In the Matter of)
) Docket 50-344
PORTLAND GENERAL ELECTRIC COMPANY,)
) (Control Building Proceeding)
et al)
)
(Trojan Nuclear Plant))

I hereby certify that on June 29, 1979, Licensee's letter to the Director of Nuclear Reactor Regulation dated June 29, 1979 and an attachment entitled "Request for Additional Information, Trojan Nuclear Plant, Proposed Control Building Design", have been served upon the persons listed below by depositing copies thereof in the United States mail with proper postage affixed for first class mail.

Trojan Nuclear Plant
Docket 50-344
License NPF-1

Enclosed are responses prepared by Bechtel Power Corporation to an additional 14 of the 50 questions submitted in your letter of May 18, 1979. In accordance with our discussion with your staff, we expect to transmit responses to the remaining questions by July 6.

Figure 3-13

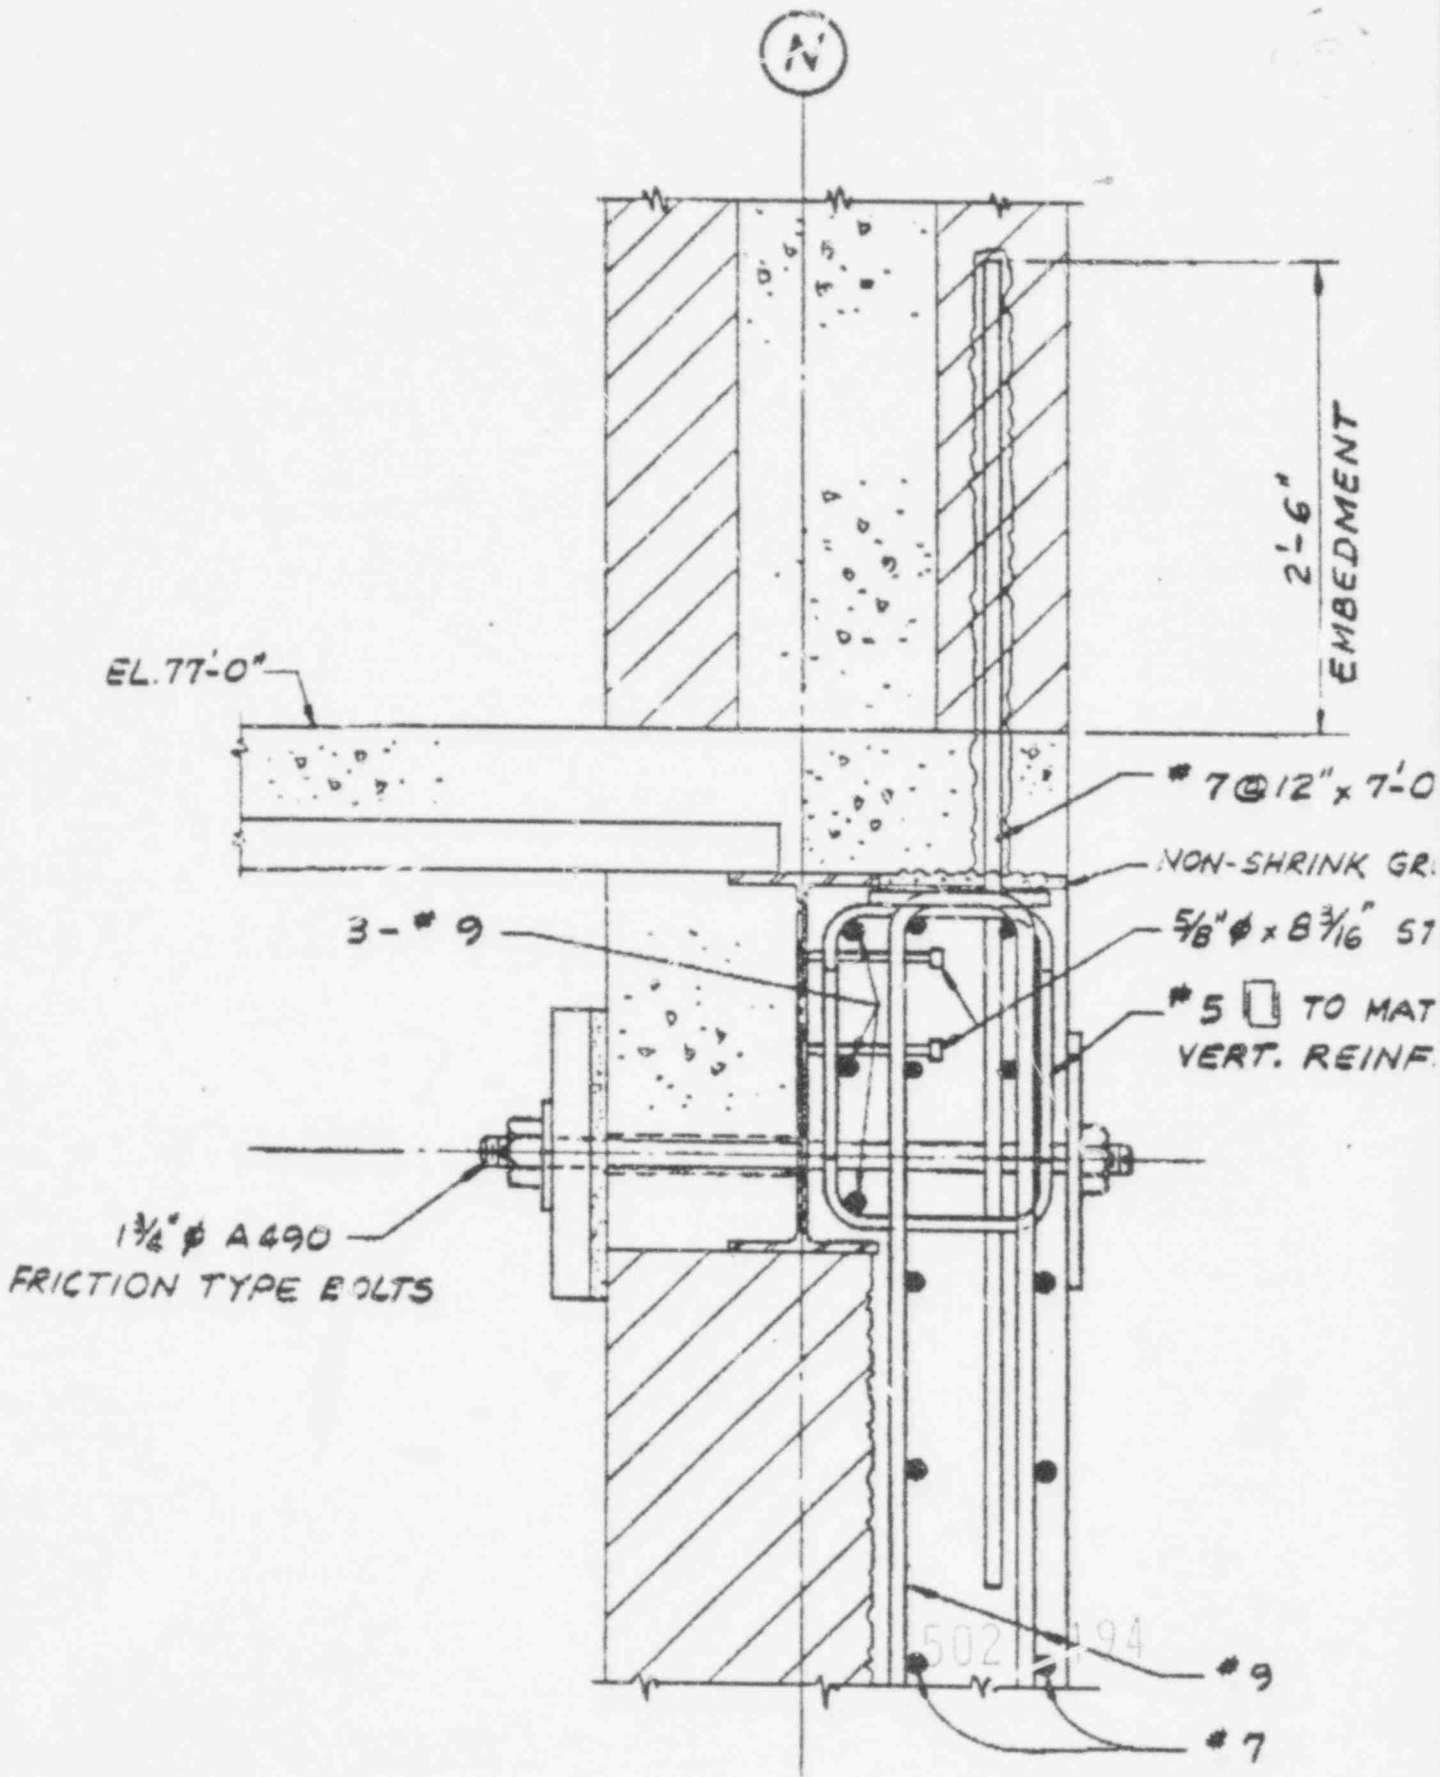
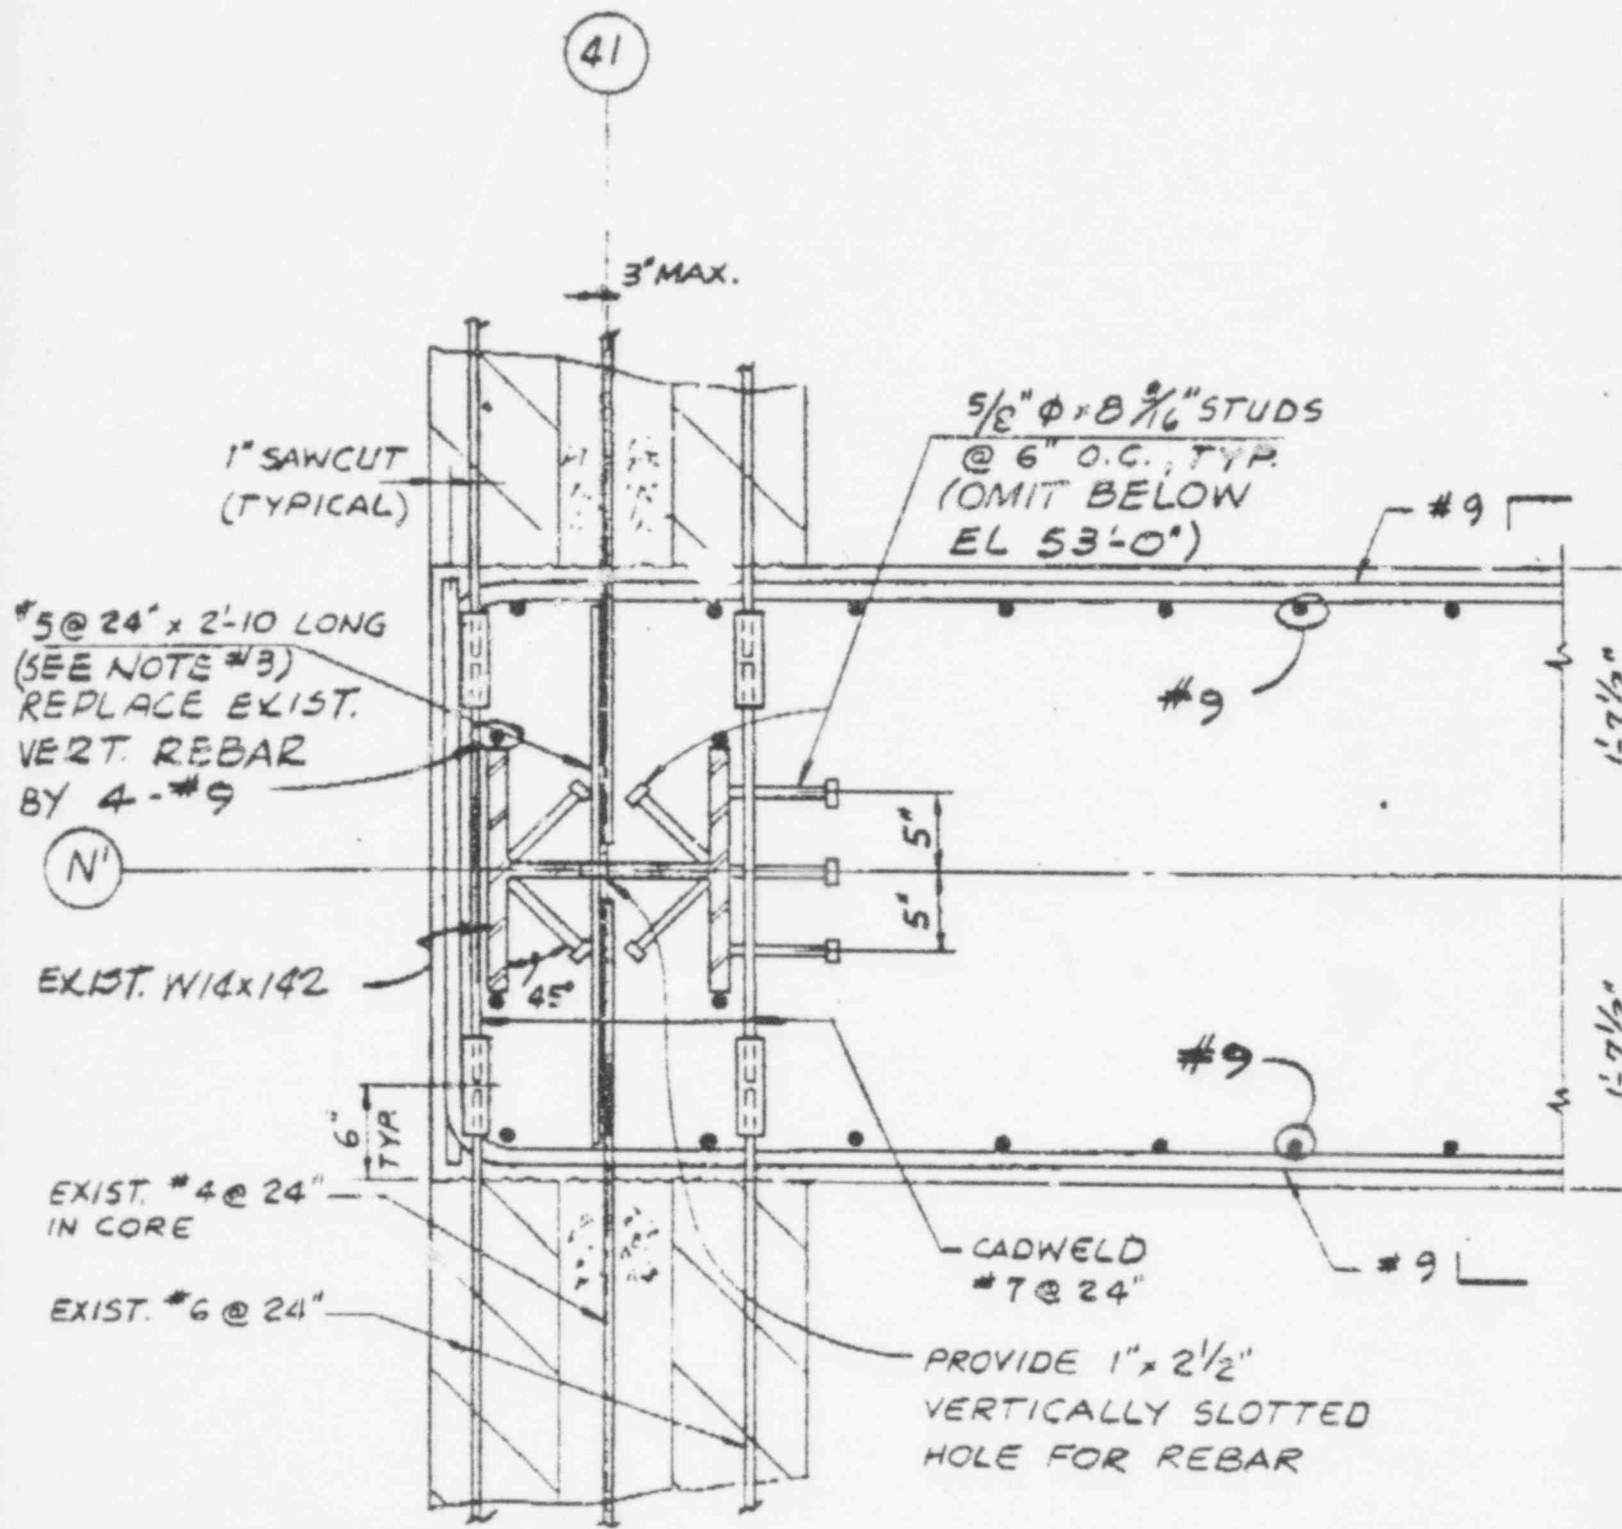
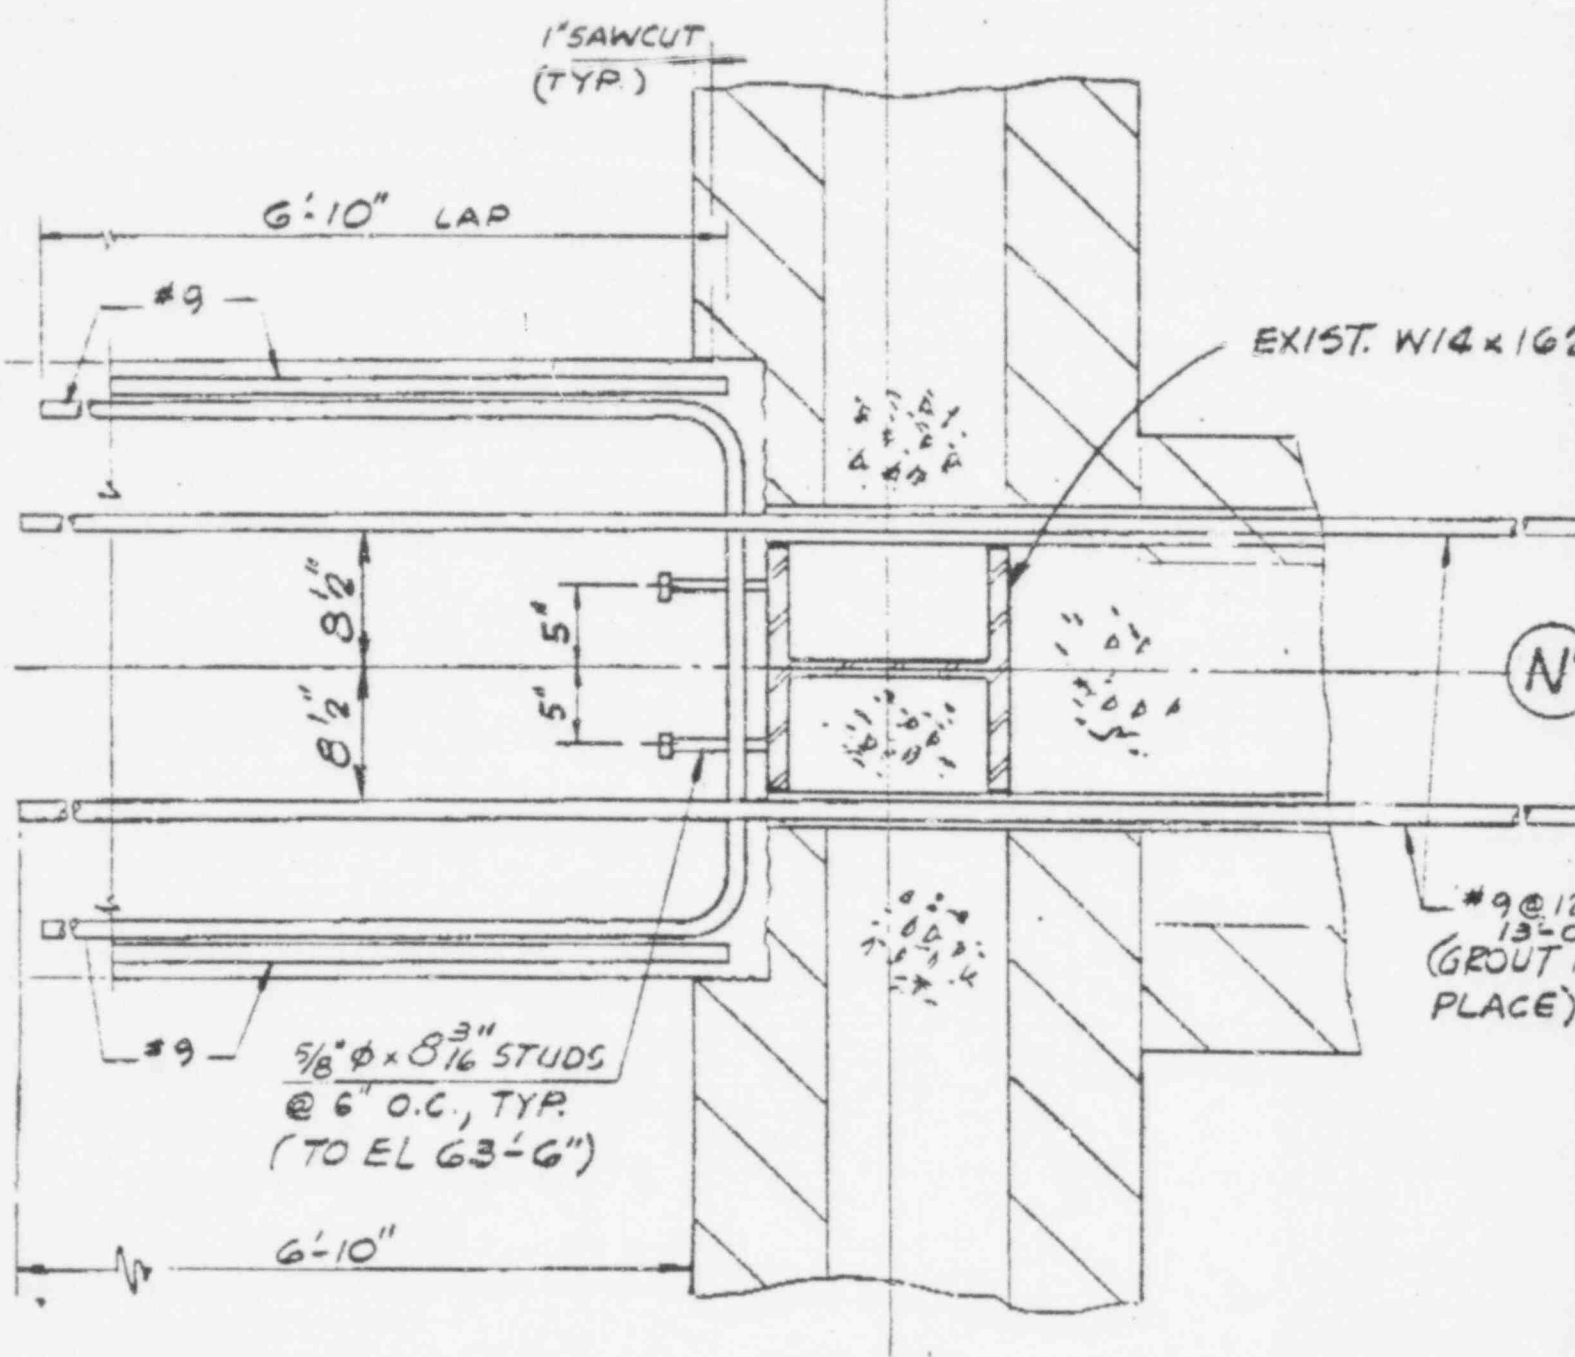
Provide clear, detailed sketches and descriptions of the connection interfaces of the additional walls to the existing structure. Additionally, describe the methods by which the effects of concrete creep and shrinkage (causing tension in the walls and/or a reduction in assumed dead weight) have been factored into the design of these additional walls. Describe and justify in detail the design and the procedures for the connections of the new walls to the existing structure.

Detailed sketches of the connection interfaces between the new walls and the existing structure are attached. The final design may require some minor revisions to the actual sizes and spacings of the rebar and studs. The sketches show representative connection details that will be used. The connection interfaces are discussed below.

Typically, where steel beams occur at a horizontal interface, studs are used to transfer shear forces and vertical rebars are used to transfer tension forces. At horizontal interfaces where steel beams do not exist, vertical rebars make the connection. In some cases friction type A-490 bolts are also used in the connections between the new walls and the existing concrete.

The typical treatment for vertical interfaces is to expose the columns and weld studs to them. New rebars are spliced with the exposed horizontal existing rebars by cadwelding. Drilled and grouted horizontal rebars are also used to make the connections.
